Vehicle Speed Sensor CHU, CXU, GU, TD

FSB 386-007, Vehicle Speed Sensor

(November 2014)

W3094986

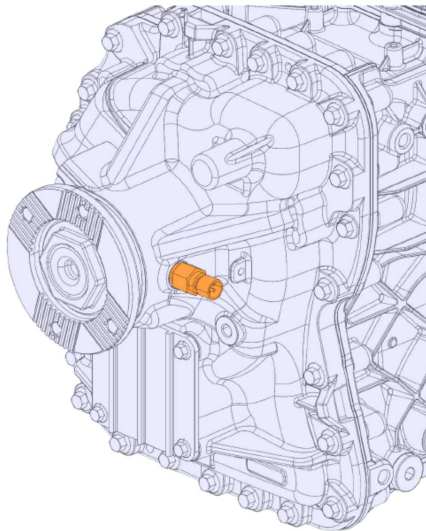
- 4 Remove the VSS from the transmission.

Note: If sensor part number 3171490 is found to have been installed and needs to be replaced, this sensor is also replaced with 22387296.

Note: If a gasket or shim is present between the sensor and transmission discard it **DO NOT** reuse with new sensor.

- 5 Install the new VSS onto the transmission and secure (part # 22387296).

- 6 Tighten the VSS to 25 ± 5 Nm (18 ± 3.7 ft-lb)
- 7 Connect the harness to the VSS.
- 8 Install all the previously removed cables to the negative (ground) battery terminals.
- 9 Remove the wheel chocks.
